SUBJECT: IN THE MATTER OF 238 NUCLEAR ISLAND  
GENERAL ELECTRIC STANDARD SAFETY ANALYSIS REPORT (GESSAR II)  
DOCKET NO. STN 50-447

Attached please find revised final draft responses to selected questions of  
the Commission's August 25, 1982 information request. Only modifications  
(new or revised) to the responses of the referenced letters are provided.  
Responses are provided in the attachments as indicated below:

DRAFT RESPONSES TO  
PROCEDURES AND TEST REVIEW BRANCH  
QUESTIONS

Figure 142-1 Power-Flow Operating Map  
(Revised)

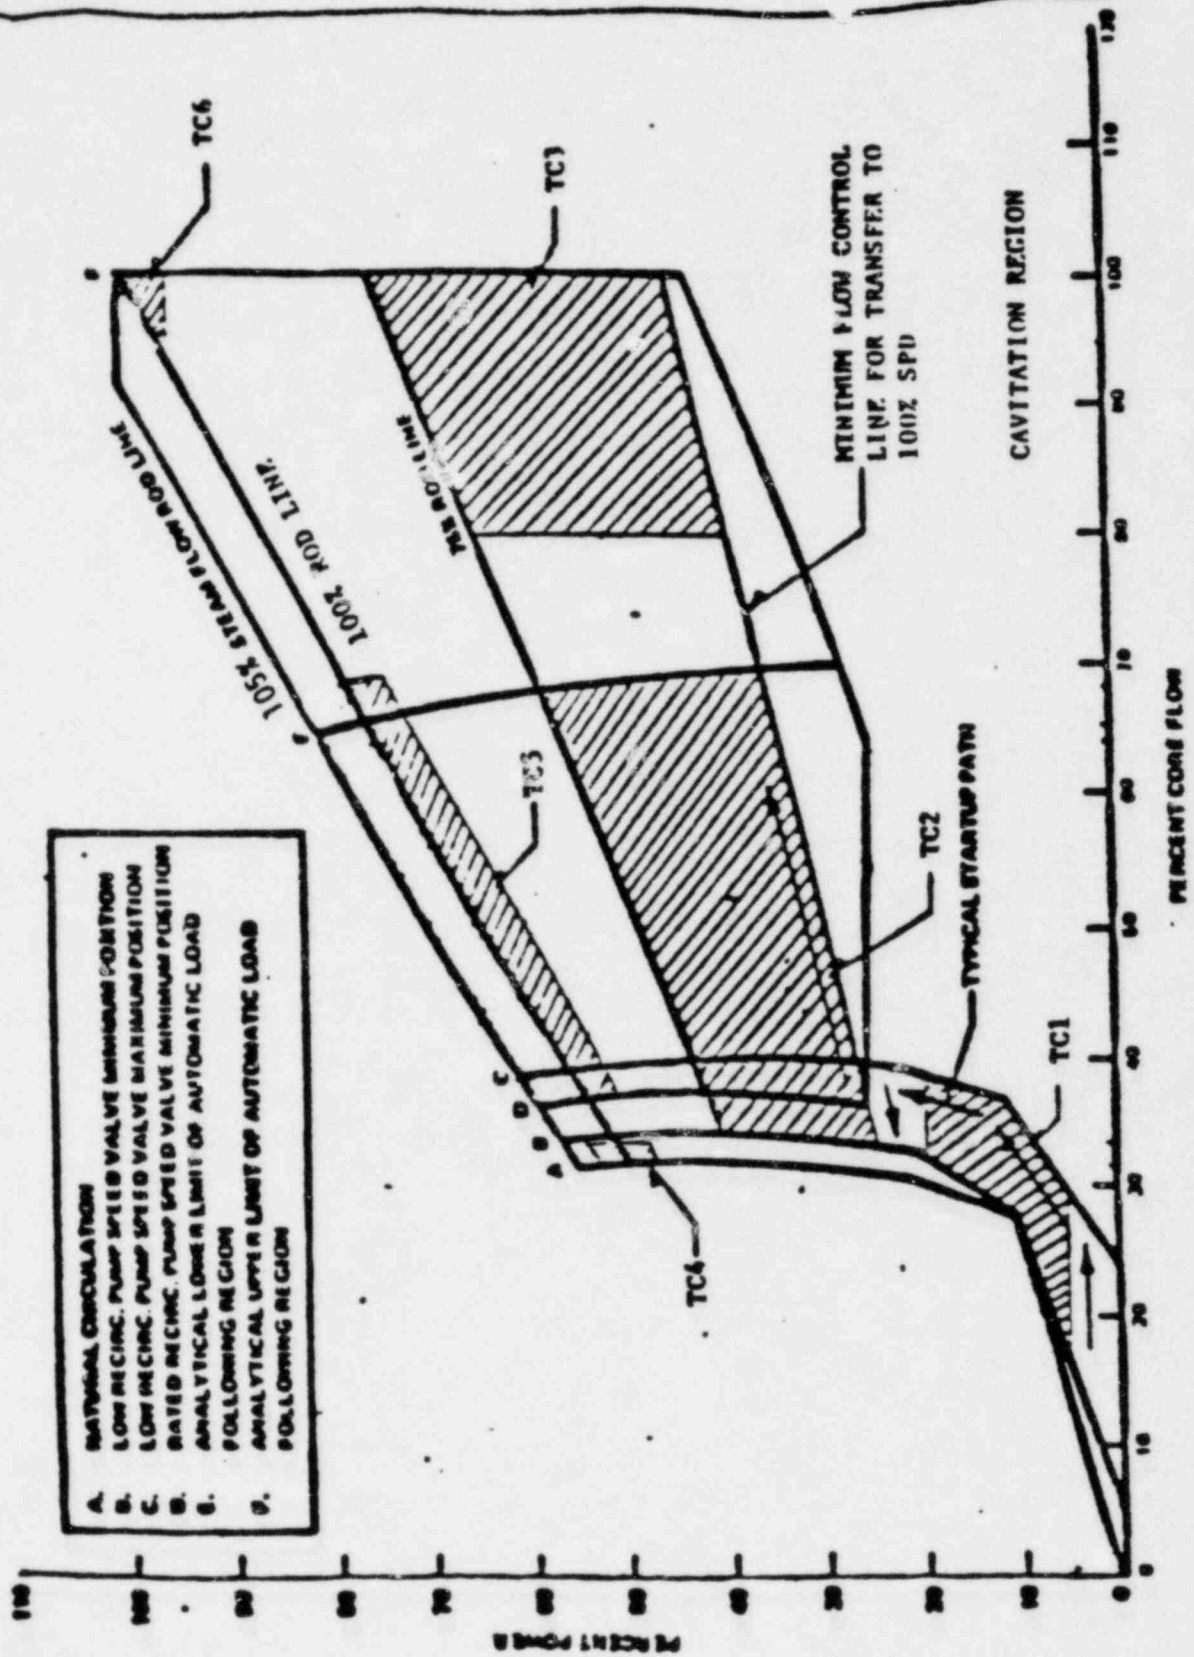
Figure revision for 640.01 and 640.02

14.3-7  
Figure 14.3-7 Trade-off Curve for Step Sizes 0.2% to 0.5%

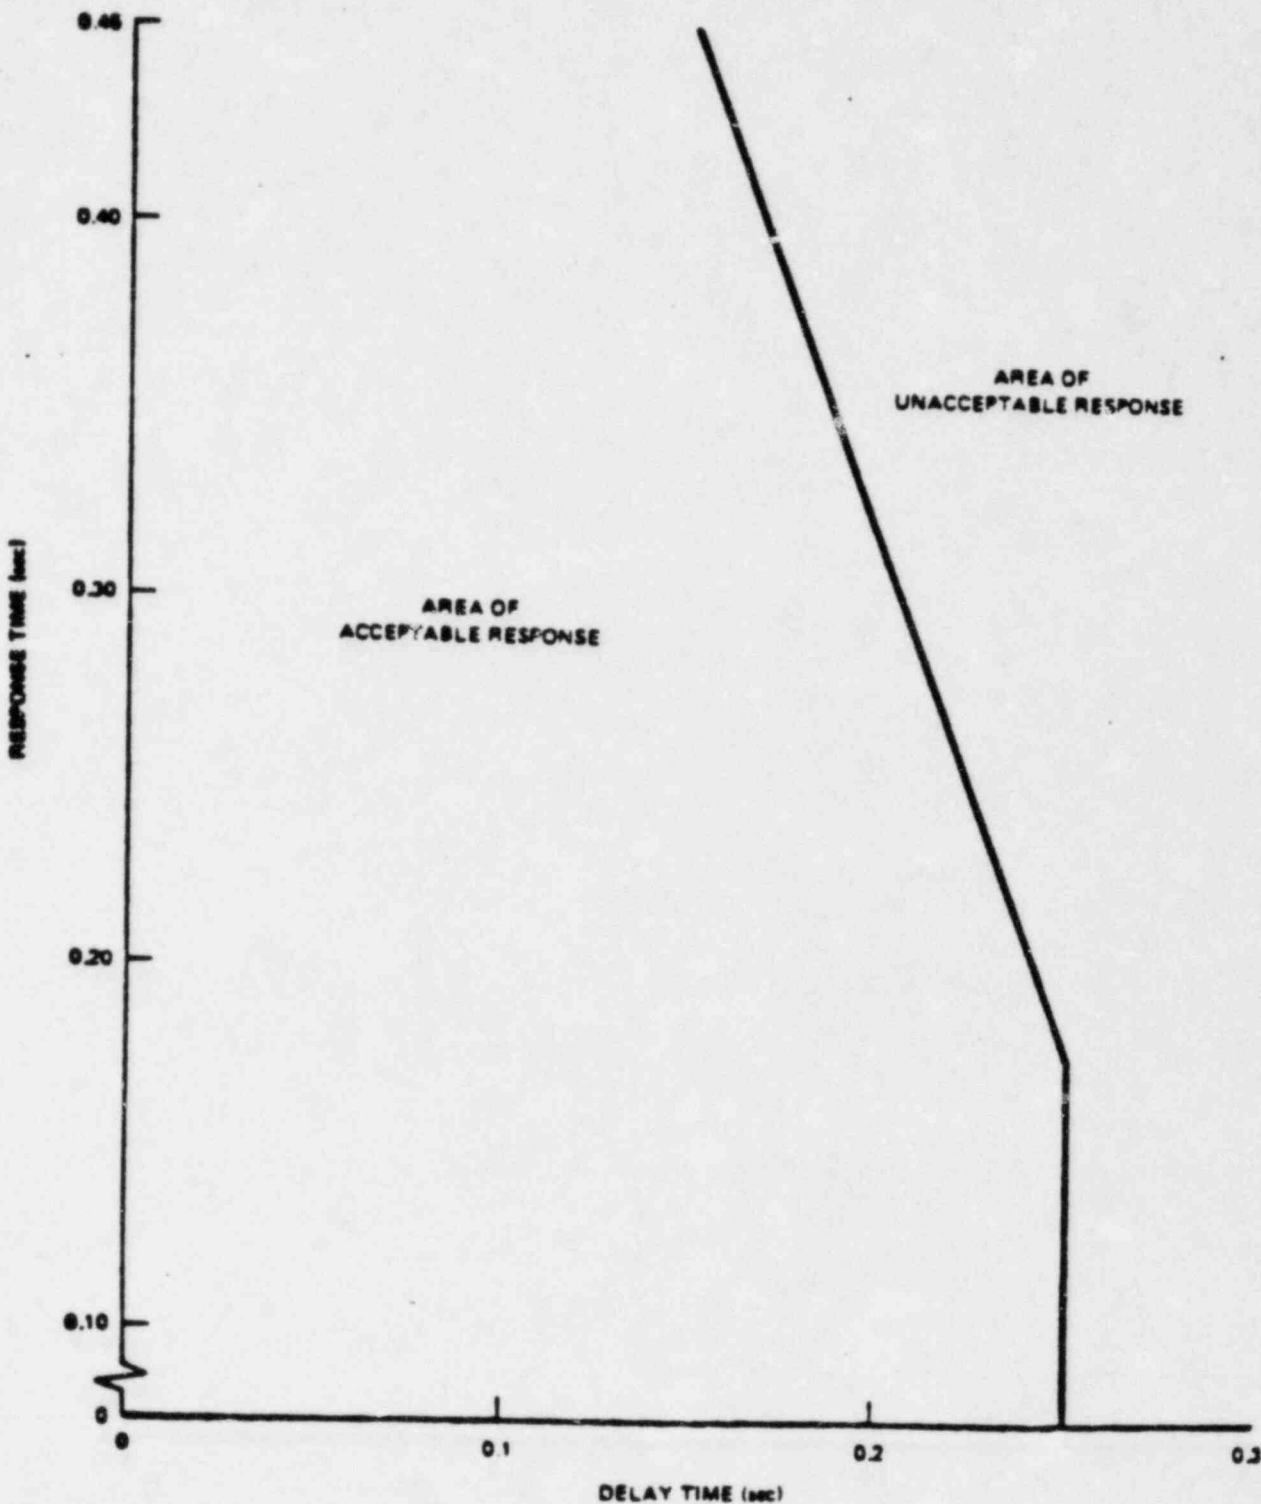
↑  
ADD THIS FIGURE

INSERT "A" TO RESPONSE 430.27

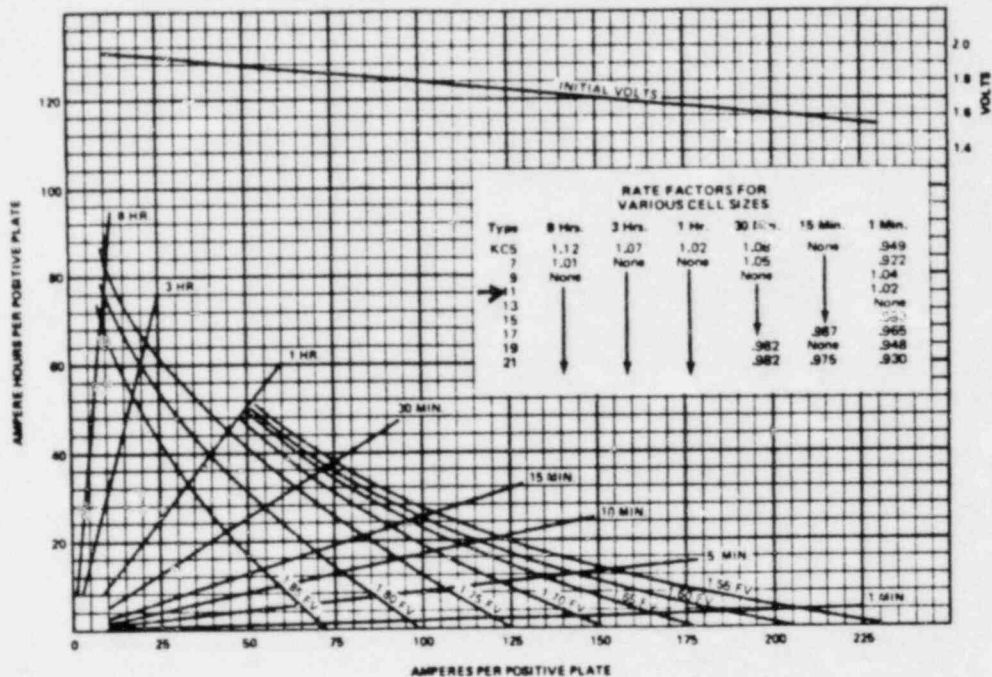
The charger is also capable of automatically regulating output voltage within  $\pm 1/2\%$  of its rated value at any load between 0 and 100%, with the ac power feeding the charger deviating from the rated voltage by  $\pm 10\%$ . Thus the Division 3 battery charger will not be affected by the voltage sag which occurs when the HPCS pump is started on the DG. The 125V DC battery will be able to maintain the bus voltage.

All dc loads connected on the division 3 dc bus are rated for operation in the voltage range of 112.5V to 137.5V.
